THE ELEVATIONS ON THE LEFT ARE OF THE CURRENTLY APROVED APPLICATION ref: DA/22/01522/FUL.

THE ELEVATIONS ON THE RIGHT ARE THE EQUIVILENT PROPOSED ELEVATIONS.

FRONT ELEVATION

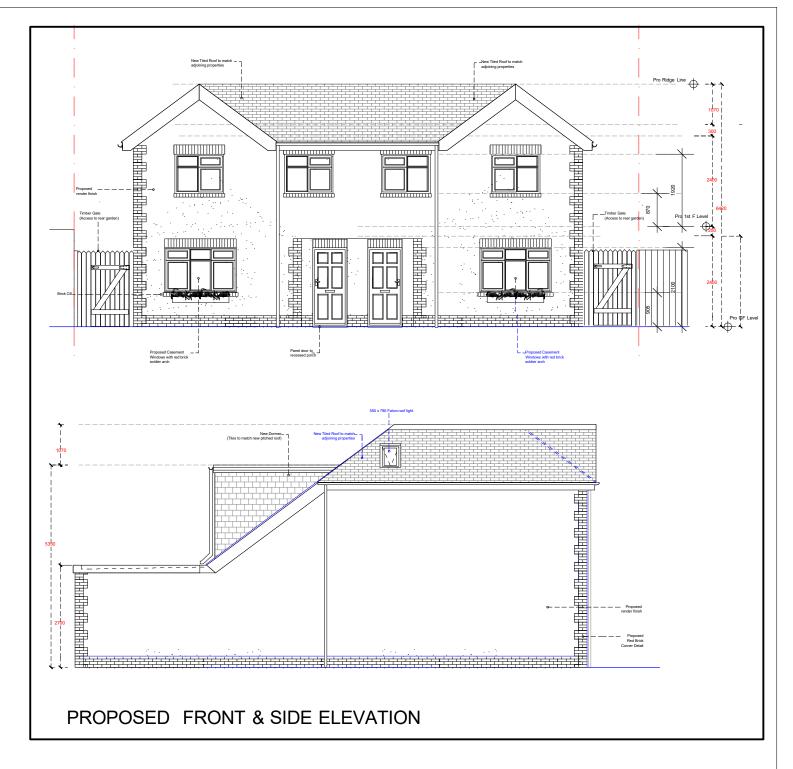
THE INCREASE IN RIDGE HEIGHT IS ONLY 360mm THE GABLES ARE REDUCED IN SIZE & ELEVATED. ROOF LIGHTS ARE OMITTED RECESSED PORCH CREATED TO ENTRANCE.

THE INCREASE IN RIDGE HEIGHT IS ONLY 360mm ROOF TO SIDE IS SLOPED REDUCING HEIGHT OF EAVE ALONG BOUNDARY ROOF LIGHT LOCATED OVER BATHROOM A 3m SINGLE STORY EXTENSION ADDED TO REAR TO ENLARGE LIVING SPACE.
